Appendix 3

Submission Summary and Recommendations for PC53

SUBMISSION SUMMARY AND RECOMMENDATIONS

Figure 3: Snip from Submission 5 sketch of Springvale Structure Plan in vicinity of 111 Mosston Road

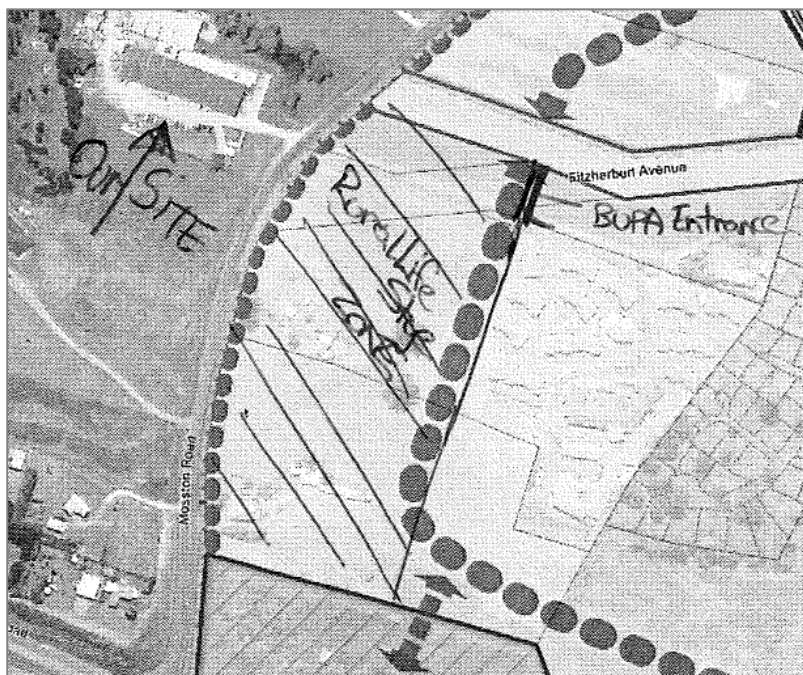
1. Opposes proposed Plan Change 53 and zoning of the land from rural lifestyle to residential. Site has been used as an engineering and manufacturing premises for over 40 years.
2. Concerned that moving the Mosston Road/ Fitzherbert Ave extension further north than previously indicated in the District Plan and rezoning land residential, that they will have 20 – 30 neighbours instead of the current two. These businesses make noise and they do not believe that highly incompatible activities next door is sound planning.

1. Revise PC53 to resemble original GHD structure plan (District Plan Appendix J) to include a buffer of rural lifestyle zoning along Mosston Road, specifically from the Fitzherbert Ave extension to the proposed reserves and open spaces zone, on the Castlecliff side.
2. Seeks the entrance to Broadview Lifecare & Village entrance at 108 Mosston Road be relocated to Fitzherbert Ave.

3. Malcolm Hunt, a noise and environmental consultant based in Wellington, assisted the Council to develop the operative District Plan noise provisions. Mr Hunt has reviewed submission 5 and the resource consent for 111 Mosston Road. He notes that although the consent purportedly limits noise at the site boundary, it is his opinion that the condition is virtually unenforceable as no standards are mentioned, nor are noise units defined. However, Mr Hunt concludes that the consent authority did purposefully allow for noise from the proposed industrial activity but also stipulated that noise should be limited in magnitude, when measured at the site boundary.

4. Overall Mr Hunt concludes that meeting Lmax 90dB at the site boundary would result in a noise effect at the closest residential receiver locations across Mosston Rd approximately equivalent to the current District Plan permitted activity noise standards.⁵

13. Mr Hunt identifies that the reverse sensitivity noise effects (if any) can apply whether or not PC53 proceeds with retention of a Rural Lifestyle Zone buffer area as originally proposed in the GHD Structure Plan 2011. He concludes that:

“There is therefore no reason to retain the buffer in the structure plan area near 111 Mosston Road, as was originally proposed in this area.”

Figure 5: Snip of Springvale Structure Plan in vicinity of 108 Mosston Road

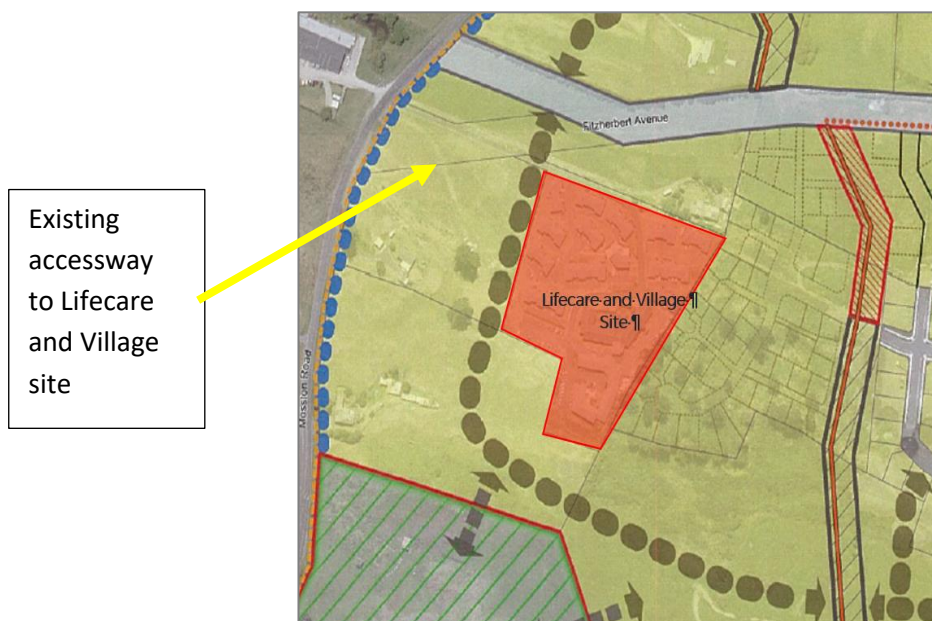
21. In response to the submitter's request to relocate the entrance to the Broadview Lifecare and Village at 108 Mosston Road to Fitzherbert Ave, Mr Evis reviewed the existing situation. He acknowledges that re-location of the entrance to either an indicative road or the Fitzherbert Avenue extension within the Structure Plan area would likely improve road safety on Mosston Road. However, any change to the existing entrance to the Village will be a decision for the landowners in discussion with Council. PC53 directs future development in the area including at the Village site to avoid Mosston Road and to establish access to Fitzherbert Avenue or other roadways within the Structure Plan area.

Figure 7: Extract of WDC Overland Flow Path at Buxton and Fox Road area

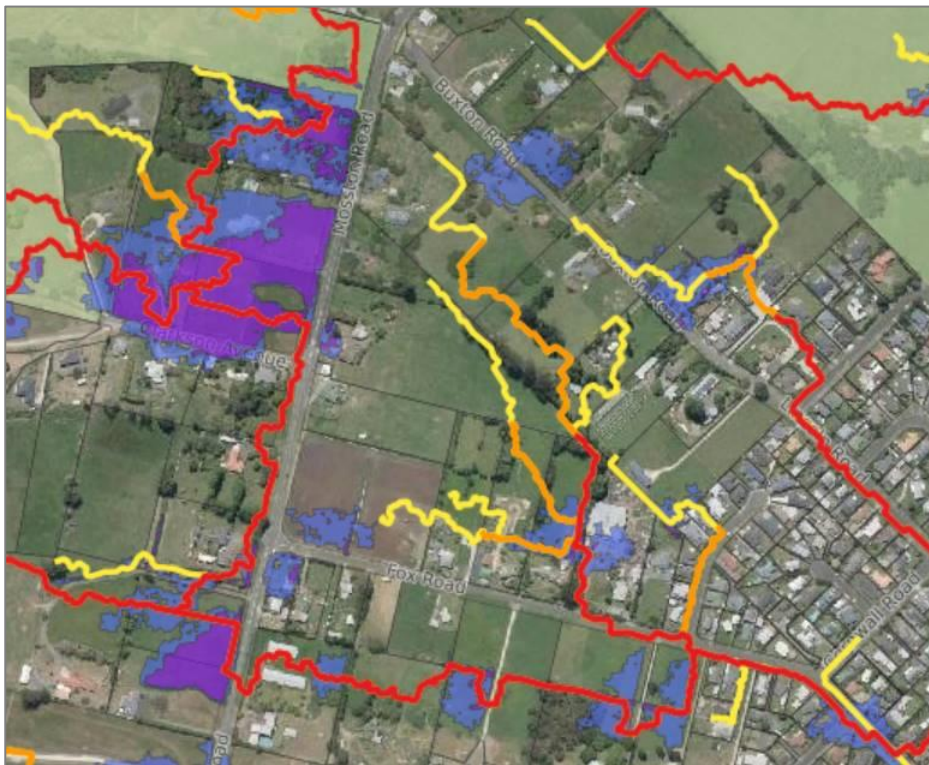
11. The submitter is concerned that HRC has no flood modelling information for this area and an apparent lack of site-specific topographical research has occurred. Overland flow path maps prepared by Cardno (NZ) Ltd and LIDAR information held by WDC were utilised by GHD to model how stormwater currently flows in a 1:200 year storm event. The modelling exercise confirmed existing constraints and the impacts of capacity constraints.

12. Council held LIDAR and previous investigations by Council Infrastructure identified that the options for stormwater alignment are incredibly limited due to topographic constraints.
